# **Sanitary Survey Report**

**Hopi High School – BIA Public Water System  
PWSID #0400395**

**Survey Conducted for the  
Environmental Protection Agency  
Region 9**

**March 23, 2018**

**Figure 1 - Photo of TastePURE Drinking Water Hose**

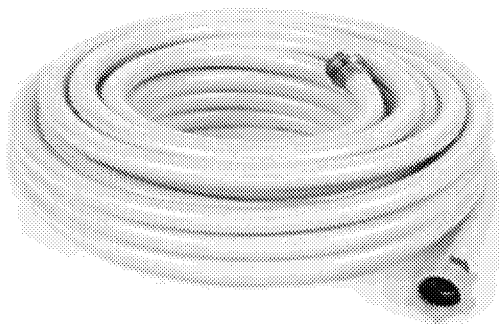
- 3. Priming the Pump (PF001 – P2 – Health Risk Priority 1) - Photo 14 and Figure 1.** Per the operator, PF001's pump has to be primed every time water is pumped from ST002 into the distribution system. The pump is primed with water from the distribution system provided through a hose that was coiled up on the floor of the treatment building during the sanitary survey. This process offers opportunities for contamination of the water system.

Given the current design with an above grade pump and a fully buried storage tank, this may not be a problem that is easy to correct. Until it can be corrected, a standard operating procedure (SOP) needs to be developed that minimizes the opportunities for contamination of the water during the pump priming process.

**Recommendation:** A standard operating procedure should be developed to ensure that the water system is not contaminated during the pump priming process. Things to consider when designing the SOP include:

- a. The conduit used to carry water from the distribution system to the point where the water is introduced for priming the pump should be designed for use with drinking water. Ideally it should be NSF- certified for use with potable water.
- b. The conduit should not be used for any other purpose and should be drained after each use.
- c. The conduit should be flushed to waste before each use.
- d. Both ends of the conduit should be capped when not in use.

**Figure 2 - Example of a flap gate.**

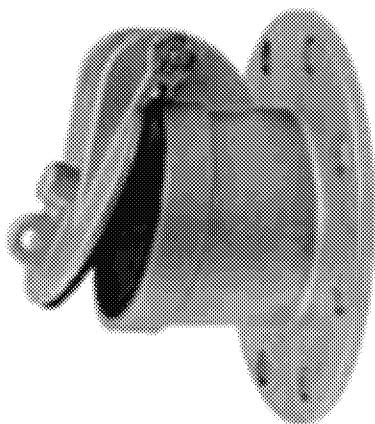
4. **Storage Tank Deficiency (ST001– ST1 – Health Risk Priority 1) - Photo 15 and Figure 2.** The overflow for the elevated storage tank is stubbed out near the foundation of the tank where a splash pad has been installed to prevent erosion and protect the tank's foundation. The overflow is screened but the openings in the screen are too large to prevent the entry of water-seeking insects like bees and wasps.

**Recommendation:** The screen should be replaced with a non-corrodible screen with openings no larger than 12-mesh (12 openings per inch both vertically and horizontally). The existing screen appears to be 4-mesh.

Another acceptable method of providing protection for overflows is to install a weighted flap gate. In theory, the flap gate will open to allow overflowing water to escape and then will close when the overflow ceases. An example of a flap gate is shown in Figure 2 below.

Note that Figure 2 shows the end of the overflow pipe has been cut at a slight angle to ensure a more tightly closing valve. Some regulatory agencies prefer to have overflows with both a flap gate and internal insect screen. Regardless of the method selected to protect overflows from insects and vermin, regular inspection and maintenance is required. Screens corrode and need regular replacement and flap gates need to be lubricated and cleaned to ensure free movement and sealing.

**Figure 4 - Sanitary seal with protected and screened vent.**

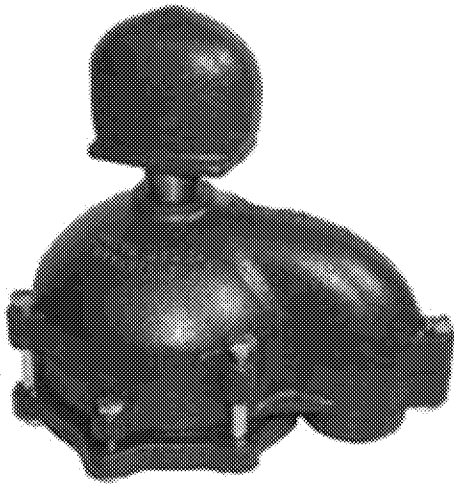
#### **11. Casing Vents (GW001, GW002, GW003 – S4 – Health Risk Priority 2) - Photos 2, 4, 7 and Figures 4 and 5.**

The three wells are all equipped with new sanitary seals. However, the sanitary seals do not have downward-facing screened vents. As water moves up and down in the well casings, during and after pumping, the casing's internal air pressure will change. Thus, air will be attempting to move into and out of the casings to equalize the pressure. With no dedicated vents, the air will move through the electrical conduits. This can force moist air into electrical controls causing corrosion and may allow contaminants to enter the casing. For example, if the buried conduit is submerged in shallow ground water, that water can be siphoned into the well casing. For these reasons, it is best to have properly designed dedicated vents.

**Recommendation:** Properly designed vents should be installed on all three wells. The sanitary seals now on the wells have a threaded port that is designed to accommodate a vent (Figure 4). This kind of vent should be available from the supplier of the sanitary seals.
